AIRWORTHINESS DIRECTIVE

THE GLIDING FEDERATION OF AUSTRALIA

GFA AD 678 Issue 1

Date: 11 February 2014

Figure 2. Locations of bolts to be inspected for "Style A" attachment bracket to all-flying tailplane.

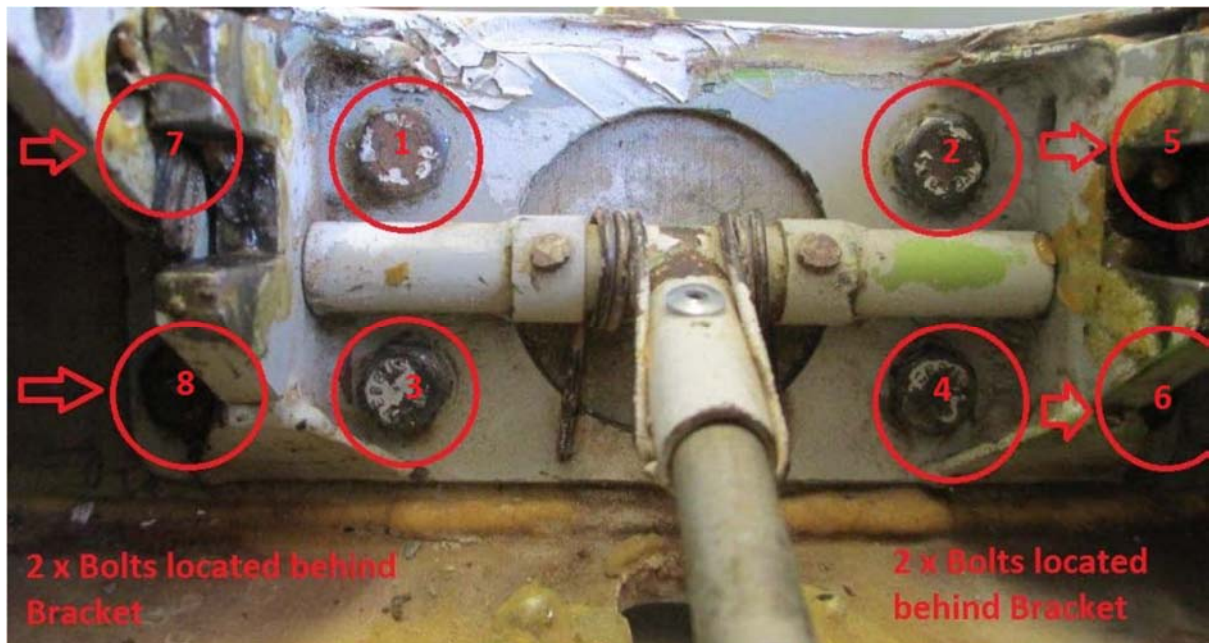
"Style A" consists of a tailplane attachment bracket fitted into the tailplane recess and attached to the tailplane by 8 Bolts passing through the tailplane spar. These are the bolts referred to in this Airworthiness Directive for "Style A" and their locations are shown in figure 2.

"Style A" is NOT affected by loose bolts at the control horn. For "Style A", the bolts to be inspected are the bolts fitted to the tailplane attachment bracket only, **NOT** the bolts fitted to the control horn. There are 8 bolts to be inspected for "Style A".

When testing for looseness of the 8 bolts, only a minimum torque is to be applied in a clockwise direction to determine looseness. **DO NOT** apply excessive torque to the bolt heads during the testing process. Loose bolts previously found have turned easily. Applying excessive torque may damage the spar by compressing the wood fibres.

If a bolt resists turning, as described above, the bolted attachment is considered serviceable.

1. Style "A" - Tailplane Attachment Bracket with spring-loaded latch - 8 Bolts:

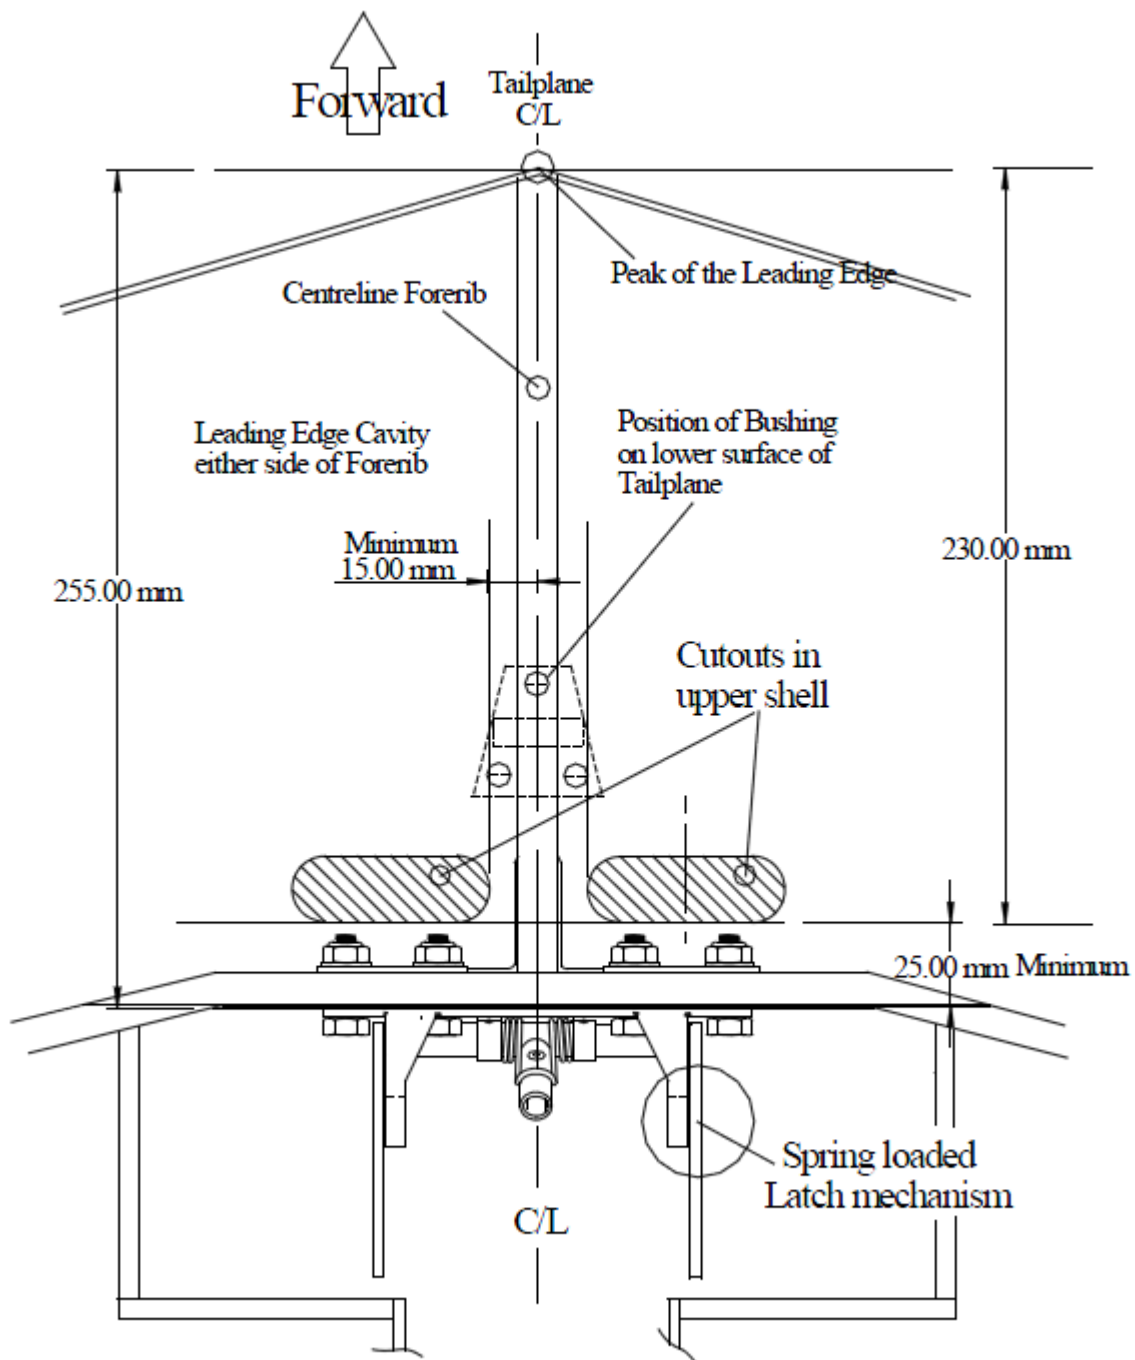
Plan View looking down onto the top surface of the Tailplane, guidance dimensions, structure and hardware shown.

Choose the dimension of the cut-outs so that a suitable tool can be used for securing the nuts.

2. Style "B" - Tailplane Attachment Bracket with Bushed Arm and Control Horn - 12 Bolts:

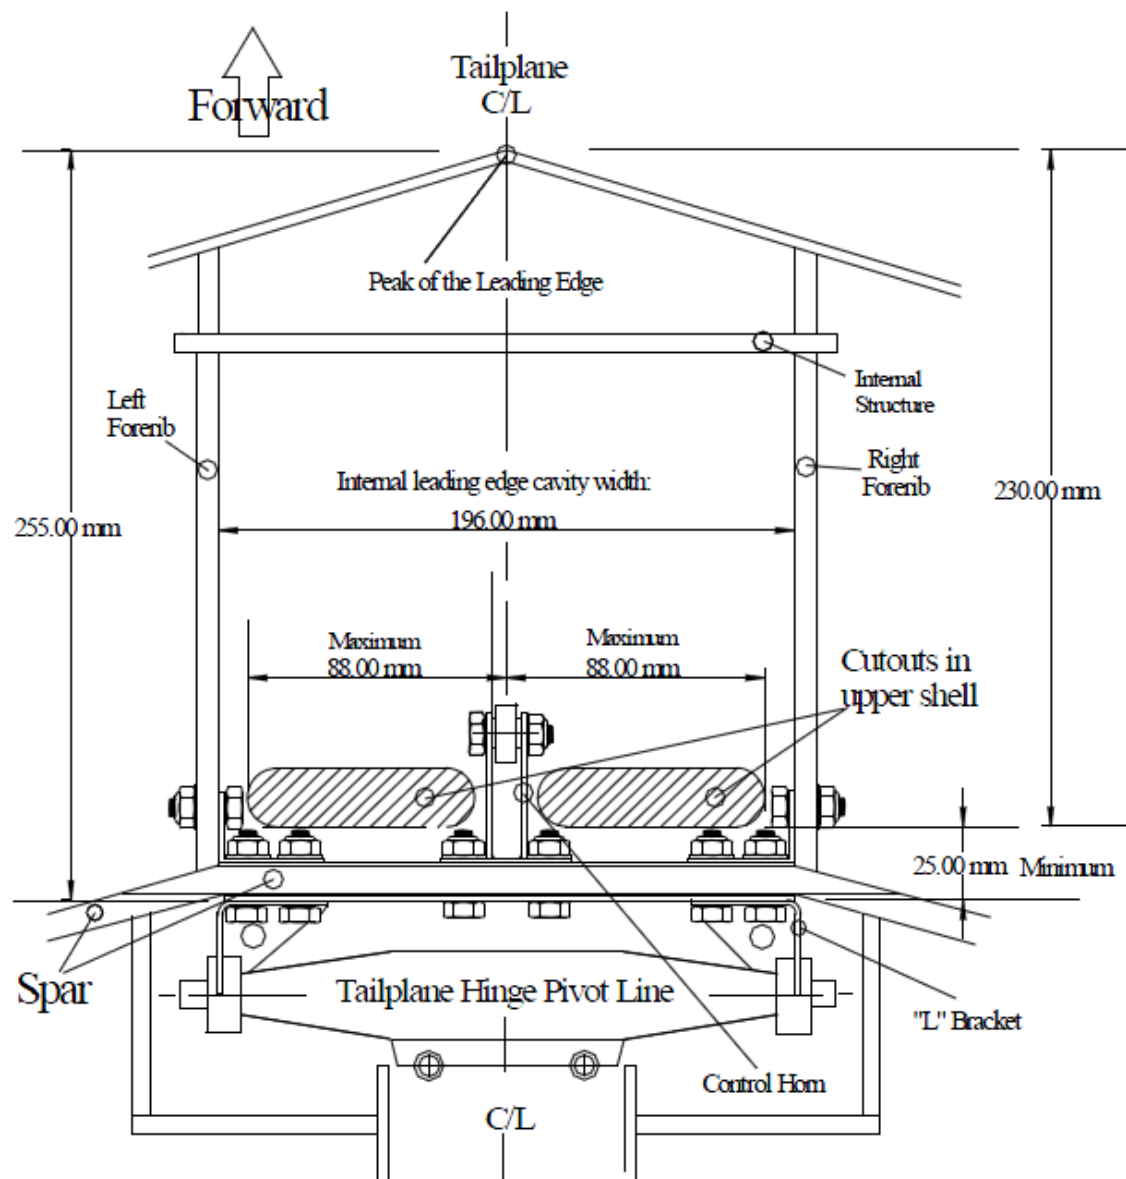
Plan View looking down onto the top surface of the Tailplane, guidance dimensions, structure and hardware shown.

Choose the dimension of the cut-outs so that a suitable tool can be used for securing the nuts.
